ADDENDUM #1
October 17, 2005

A3 Studio
343 West Water St.
Kerrville, TX 78028

Kerrville Schreiner Park
Renovations
2385 Bandera Road
Kerrville, Texas 78028

SK-01

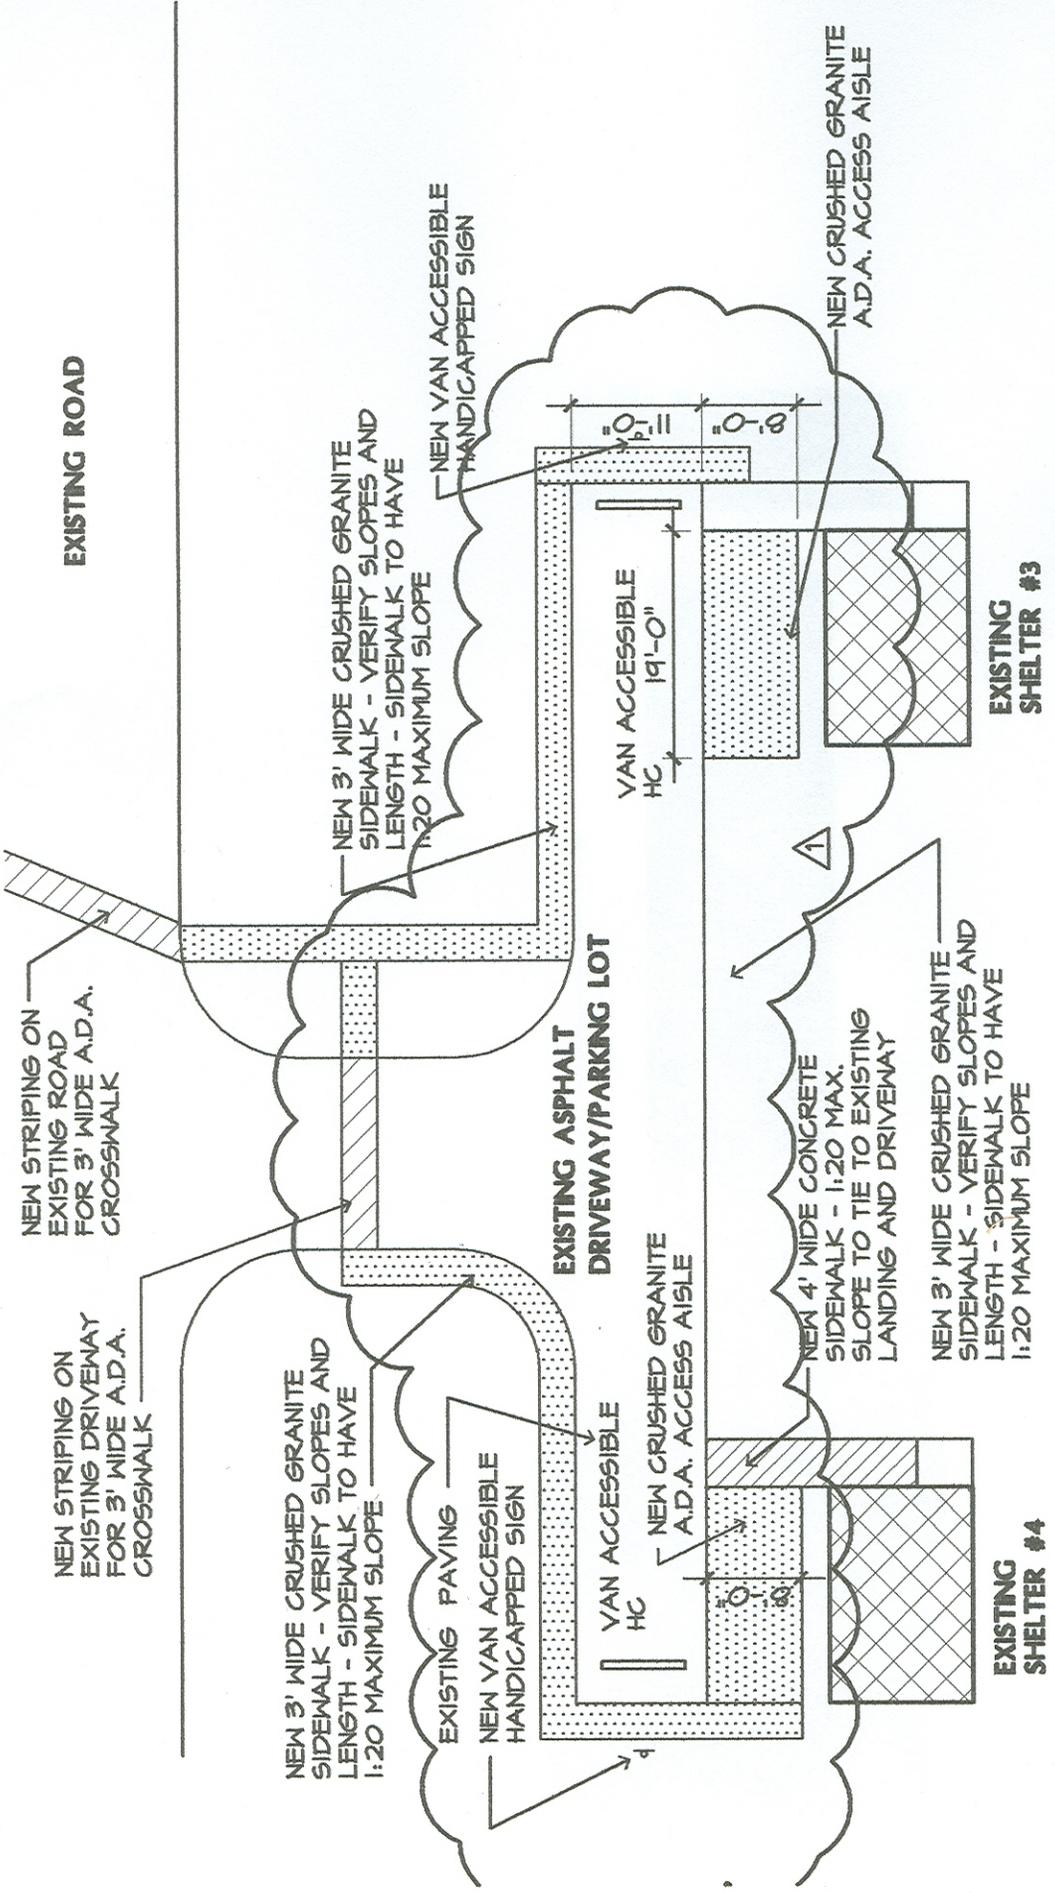
1. Sheet A-1: Revise paths from Shelter #3 and #4 to avoid accessible route traveling behind parked cars. Refer to revised sketch SK-01, enclosed.
2. Sheet A-1: Add 5' x 5' crushed granite passing area at a mid point along the 230' (+-) crushed granite path to the restrooms.
